SUBJECT: R.E. Ginna Nuclear Power Plant
Docket No. 50-244

Third Supplemental Response to NRC Generic Letter 2004-002, "Potential Impact of Debris Blockage on Emergency Recirculation During Design Basis Accidents at Pressurized-Water Reactors"

REGNPP GL 2004-02 THIRD SUPPLEMENTAL RAI RESPONSE

Figure 3.3 – Distribution of Small and Large Pieces of Debris in Lower Containment

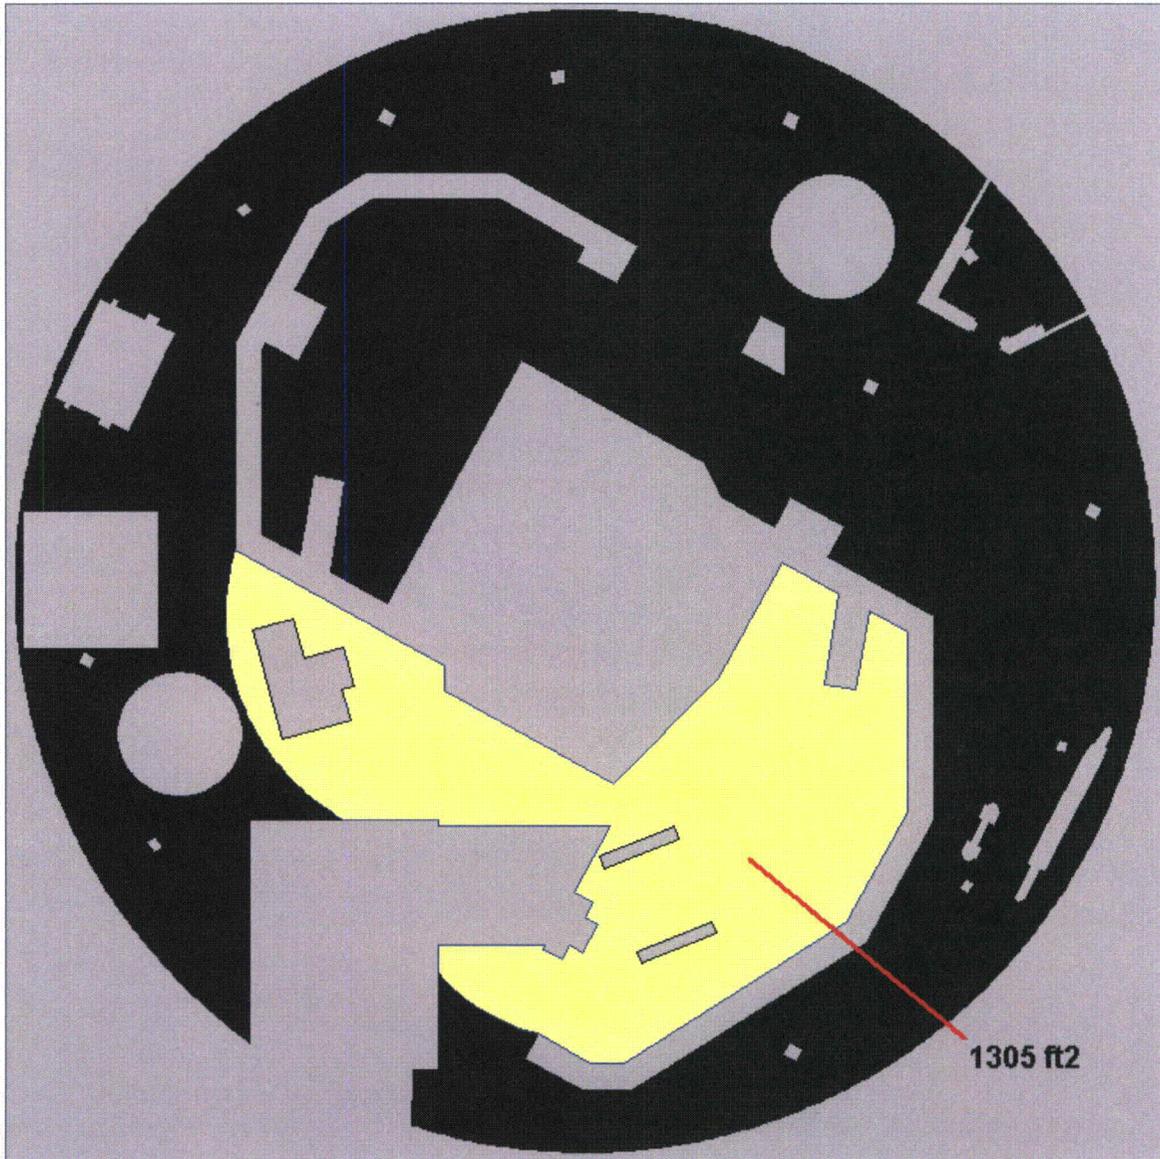
Figure shows that the turbulence in the pool is only high enough to suspend small pieces of RMI in the vicinity of the break. Since the small pieces of RMI would settle in most of the pool, the tumbling velocity is the predominant means of transport.

The small RMI debris was assumed to be distributed as shown in Figure 3.33.3. This area was overlaid on top of the plot showing tumbling velocity and flow vectors to determine the recirculation transport fraction.

The area where small pieces of RMI would transport within the initial distribution area is 506 ft² as shown in Figure 3.43.4. Since the initial distribution area was determined to be 1,305 ft², the recirculation transport fraction for small pieces of RMI is 39%.

Figure 3.7 – Temp-Mat Small Pieces Debris Transport Logic Tree (Case 1)

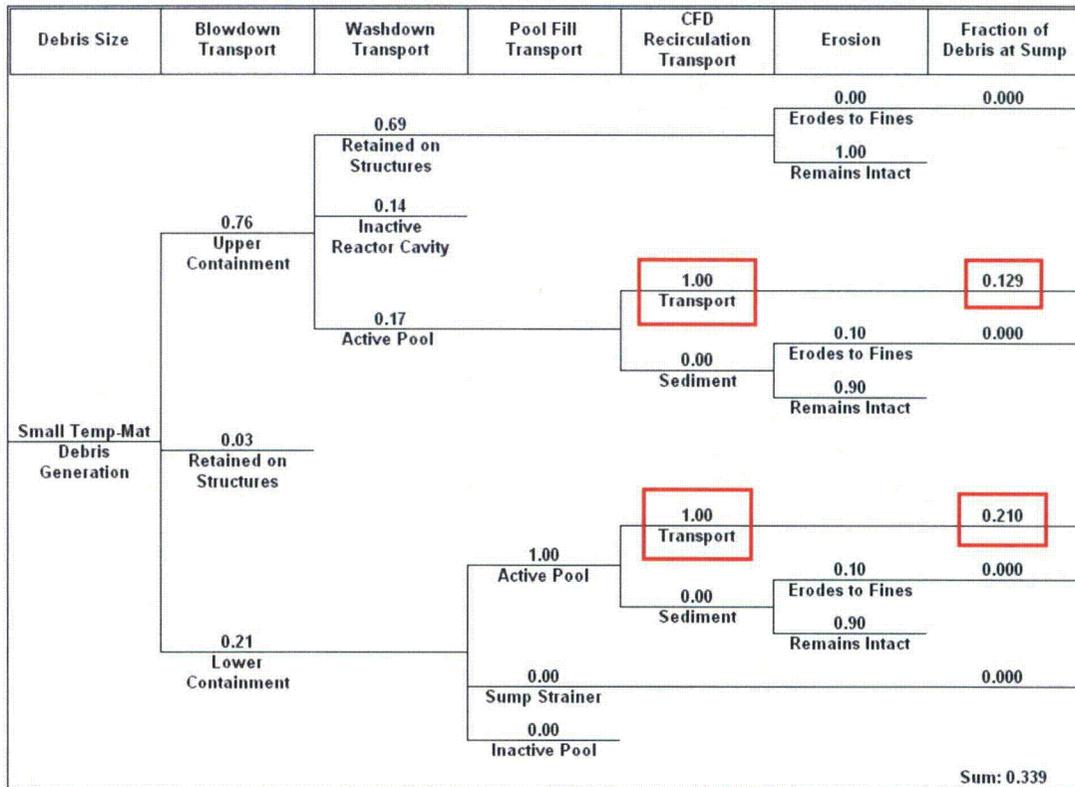
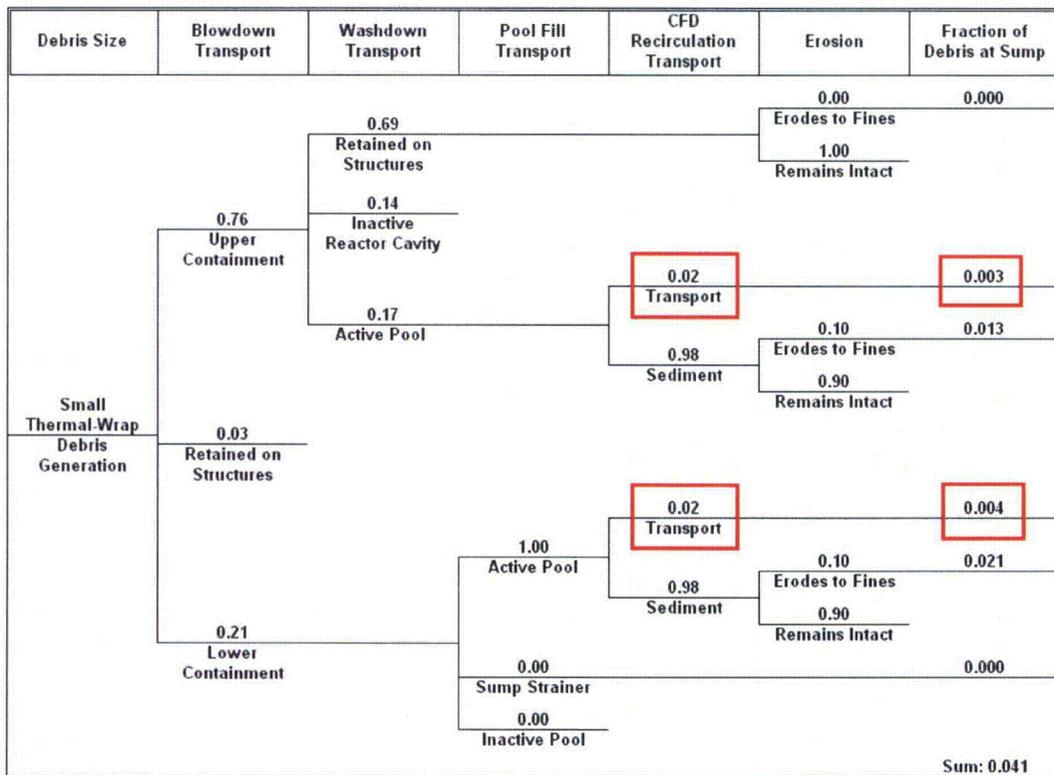
- j) *A discussion as to why the transport fractions for Temp-Mat are higher than for Thermal Wrap. Presumably, the denser fiberglass (Temp-Mat) would be less transportable for equivalent sizes of debris than the less dense fiberglass (Thermal Wrap). However, the results presented in the supplemental response show the opposite behavior.*

Within the small and large piece Thermal-Wrap logic trees, the calculated recirculation transport fractions were used. However, for Temp-Mat small and large pieces, the logic trees conservatively assumed that all small and large pieces of Temp-Mat in the containment pool transport to the sump (a recirculation transport fraction of 100%). Using two example logic trees from a single case and debris size (Figure 3.73.7 and Figure 3.8), it can be seen that using the actual transport fraction for Thermal-Wrap and an overly-conservative 100% transport fraction for Temp-Mat accounts for this difference.

Figure 5.1: CCI Multi-functional Test Loop

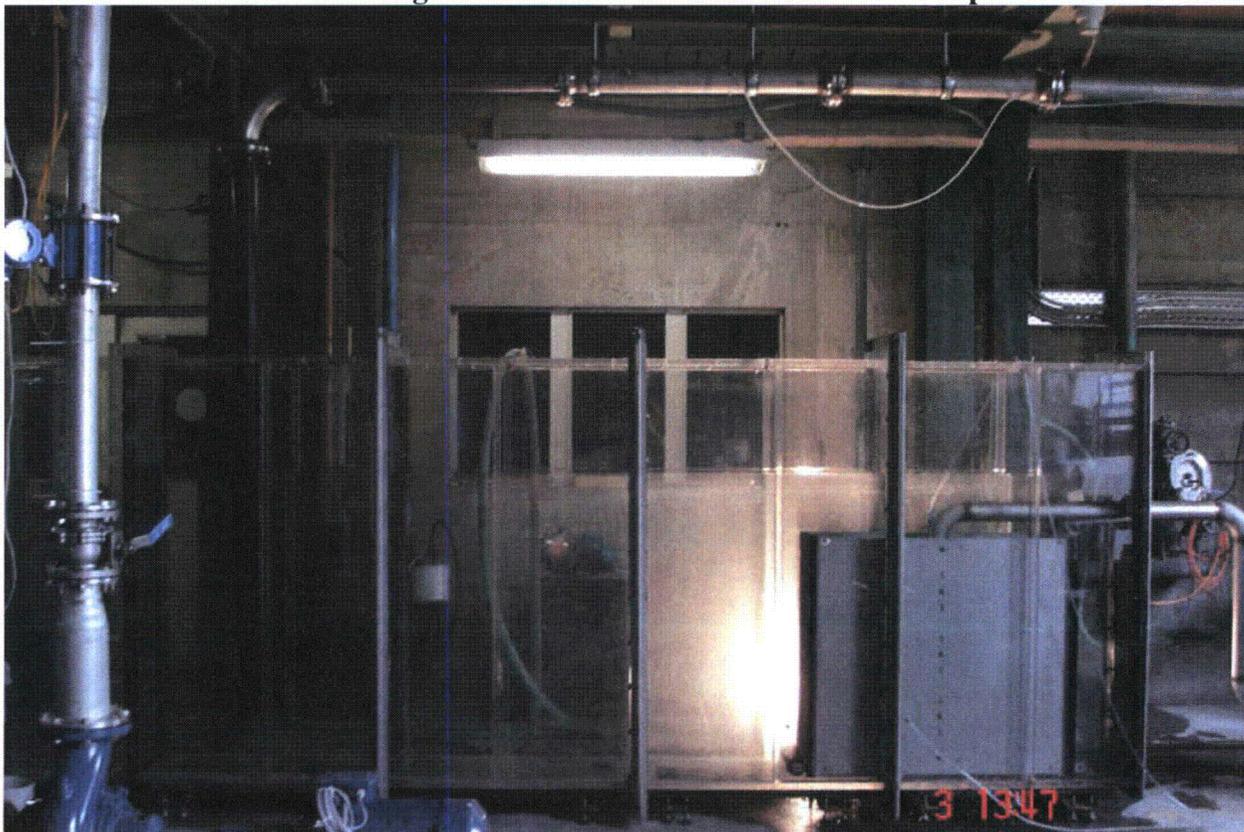
RAI-5: *Please provide details of the debris addition procedures used. Please include a description of fibrous concentration during debris addition, the debris addition location, and the method of adding fibrous debris to the test tank. Please provide verification that the debris introduction processes did not result in non-prototypical settling, agglomeration, or deposition of debris.*

RAI-5 Response: The test loop in which strainer head loss testing was conducted consists of a tank approximately 12 m long x 0.5 m wide x 2 m high. A double sided strainer segment is positioned at one end of the test tank. Pump suction is taken from the center channel of the strainer and circulated to the opposite end of the test tank, through a submerged sparger. Test debris is added to the test tank near the surface of the tank water above the sparger location (Figure 5.1).

Figure 6.1: Full Debris Load, Including Chemical Precipitate

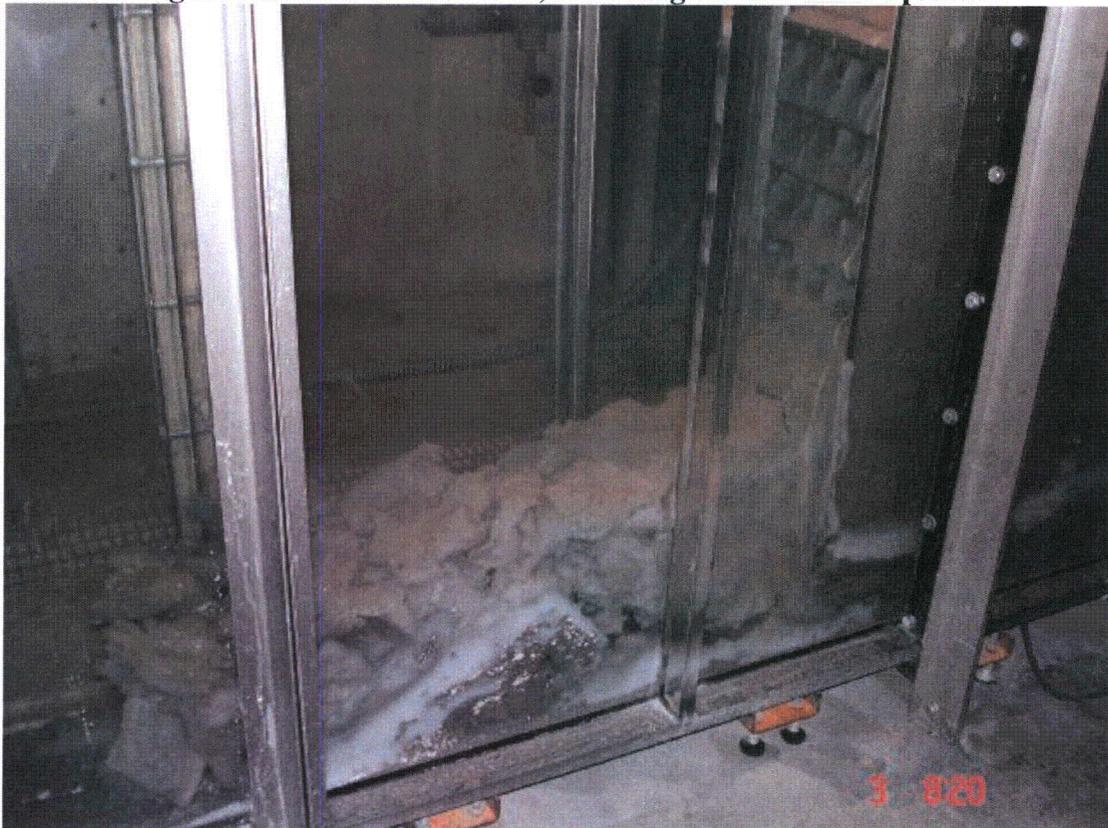
RAI-6: *If the test(s) allowed near-field settling, please provide a comparison of the flows predicted around the strainer in the plant versus the flows present in the test flume. Please show that the test velocities and turbulence levels were prototypical or conservative compared to the plant. If the test(s) allowed settling, please provide the amount (percentage by type) of debris that settled in the test tank.*

No statement can be made to the actual percentages by type of debris which settled immediately in front of the strainer. The over-whelming majority of the fiber fines transported into the strainer pockets. The majority of the near field settling on the bottom of the test loop was made up of larger fiber pieces, paint chips and RMI (Figure 6.1).

Figure 8.1: Ginna Strainer Head Loss Test 1 Results

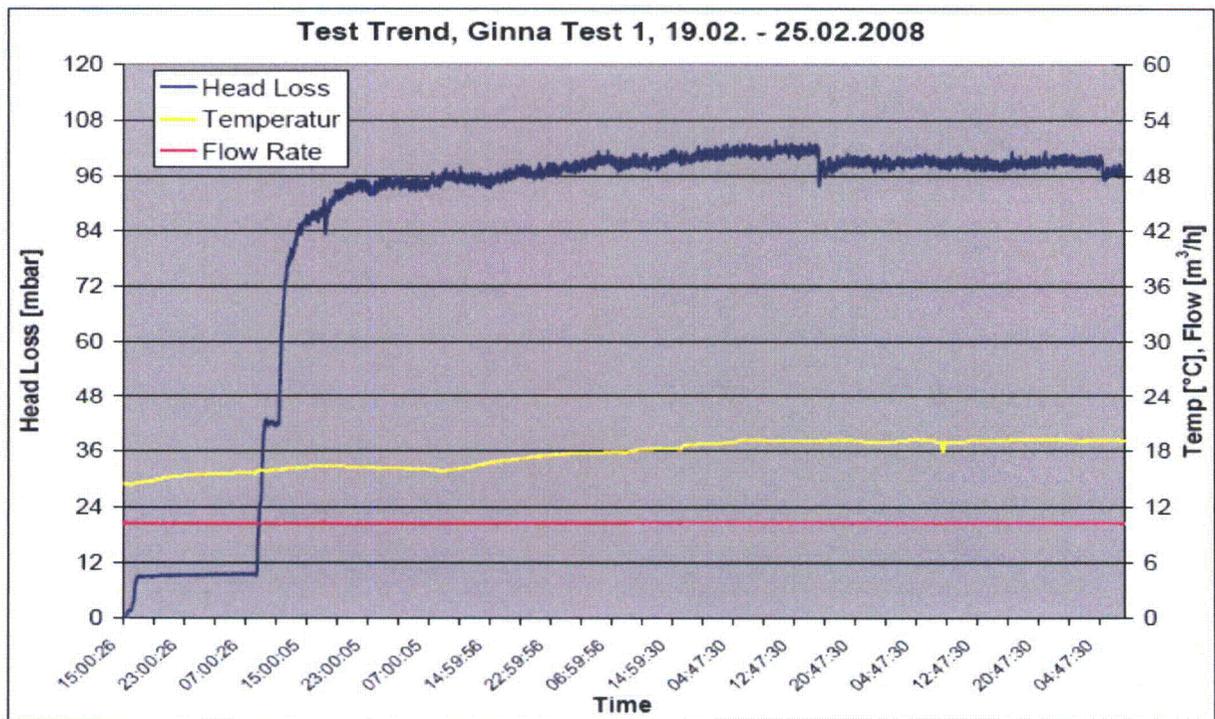
RAI-8: *Please provide the test termination criteria and the methodology by which the final head loss values were extrapolated to the ECCS mission time or some predicted steady state value. Please include enough test data to allow the extrapolation results to be verified.*

During strainer head loss testing, head loss values were taken every 30 seconds. As can be seen in the Test 1 plot of strainer head loss values (Figure 8.1), the head loss was stable for nearly 2 days prior to the termination of the test. The head loss during this time had minimal variation (± 2 mbar) and the overall trend was steady, to trending down. As a result, it was determined that the maximum strainer head loss had been achieved and no extrapolation of head loss data was performed. The maximum head loss achieved during the test, adjusted for test tank fluid temperature variations and normalized to 20 °C, was 95.2 mbar [8.4]. Since this head loss was the maximum achieved and since subsequent head loss measurements were lower and stable, to trending down, 95.2 mbar at 20 °C was taken as the maximum sump strainer head loss due to debris on the strainer. This value is equivalent to 29.7 mbar (0.99 ft WC) corrected to the minimum containment recirculation pool design temperature of 195 °F.

Figure 12.1: Ginna Strainer Head Loss Test 1 Results

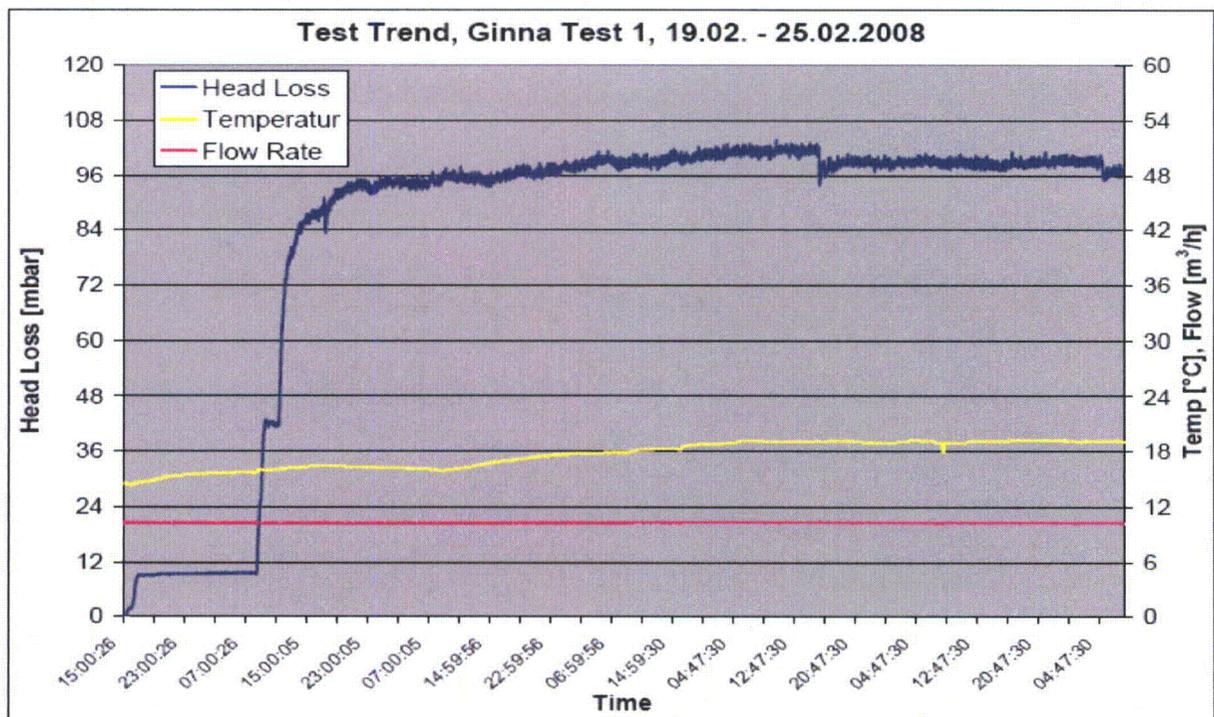
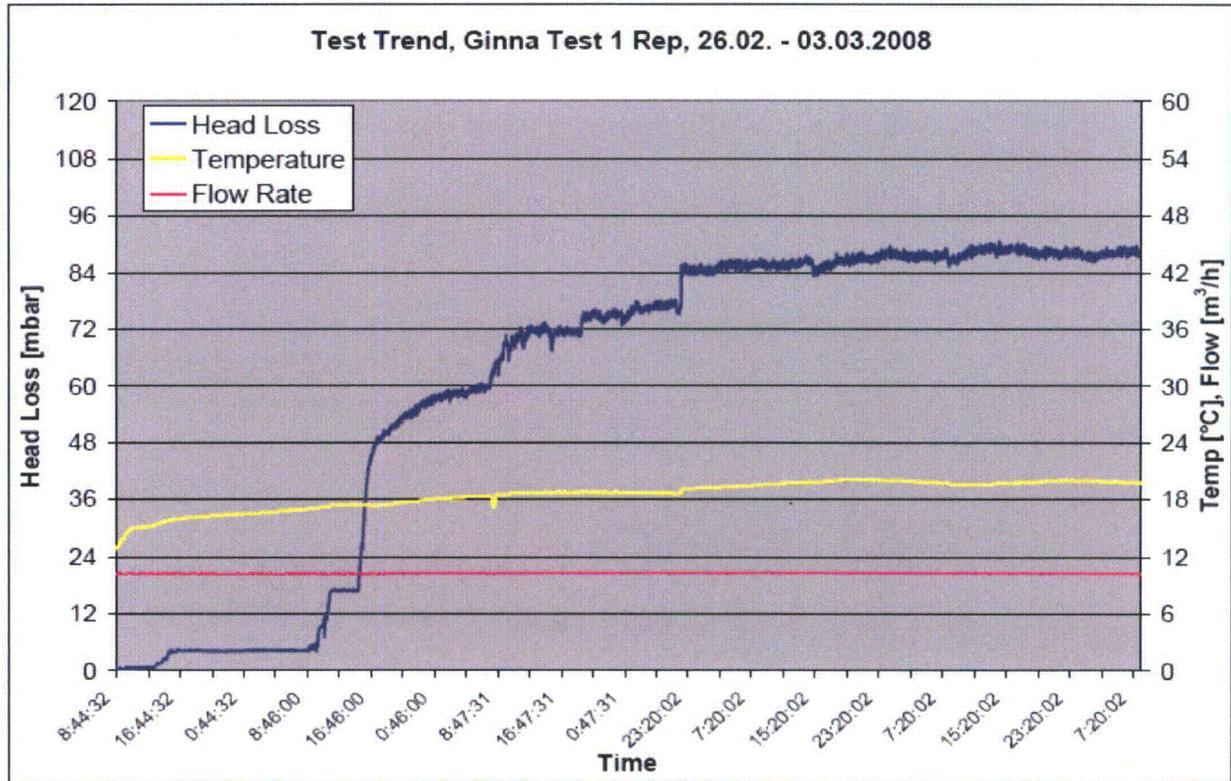
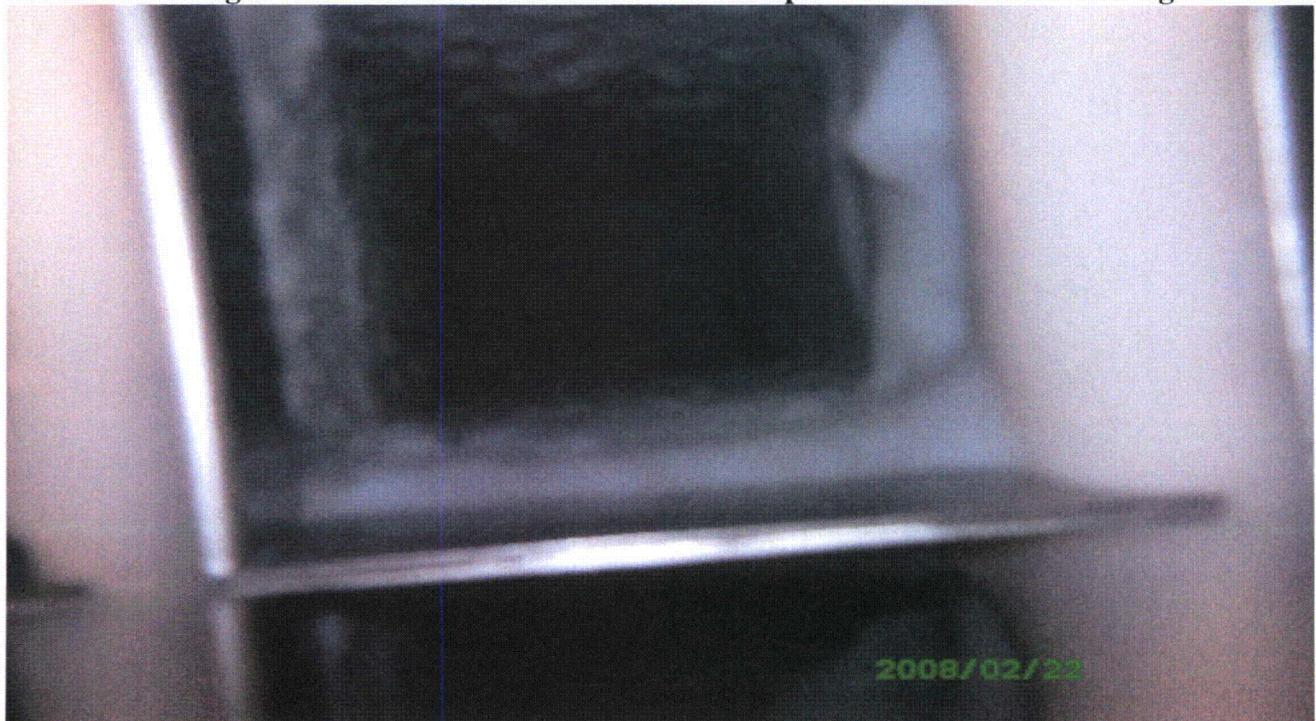
RAI-12: Please provide information that shows that pressure-related phenomena (e.g., boreholes or channeling) did not occur during testing. A description of flow sweeps conducted following testing that shows a head loss change is approximately proportional to flow change is acceptable for this purpose.

RAI-12 Response: The results of the Ginna head loss testing with full debris load, including chemical precipitants, (Figure 12.1 and 12.2) showed no evidence of bore holes or channeling. The strainer head loss over the 4 days of testing, following the introduction of debris, showed minimal variation of head loss and no open strainer surface area. The variation of head loss, from peak to trough, was approximately 6 mbar, with no sudden change of head loss that could be attributed to any pressure related phenomena. This conclusion was further supported by direct observation of the debris bed (Figure 12.3). Two separate tests were conducted with very similar results. Had any pressure related phenomena existed, the results of these tests would not have so closely resembled each other. The strainer head loss, for which temperature/viscosity correction was applied, was taken as the most conservative value for the head loss and test pool water temperature.
